CR018 GPII Inductor Rule Violation SOT

CR018 GPII IND Rule Violation SOTE

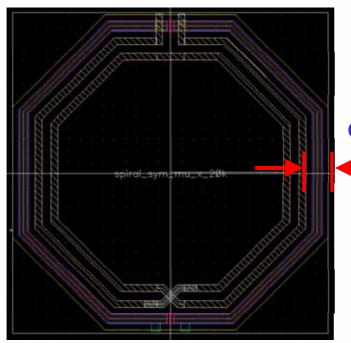
GRDIST=Distance between coil and INDDMY

- •Customer may suffer the rule violation (UTM20K.E.3 & UTM40K.E.3) as using CR018 GPII Inductor PDK, due to TSMC had offered scalable guard-ring distance (10um~50um) for inductor of CR018 GPII. (T-018-LO-DR-001).
- Current rules definition:

- TSMC will relax the rule and update DRM in 2010/Q2. "T-018-LO-DR-001"
- Please customer waive the rule violation caused by guard-ring distance as using CR018 GPII PDK, until DRM and new DRC deck update.
- The new rules update will be defined as following table: (It will be treated as recommendation rules).

Minimum extension of dummy"layer "INDDMY" region beyond one UTM region which used as one inductor device.↵	G₽	≧₽	10₽
UTM20K.E.3 ^u dRecommendations:				
	Keep INDDMY regions for separate inductors located as uniformly as possible over the whole chip area.₽			
UTM40K.E.3 ^v +	Minimum extension of dummy"layer "INDDMY" region beyond one UTM region which used as one inductor device.√	G₽	A P	10₽
	Recommendations:			
	Keep INDDMY regions for separate inductors located as uniformly as			
	possible over the whole chip area.
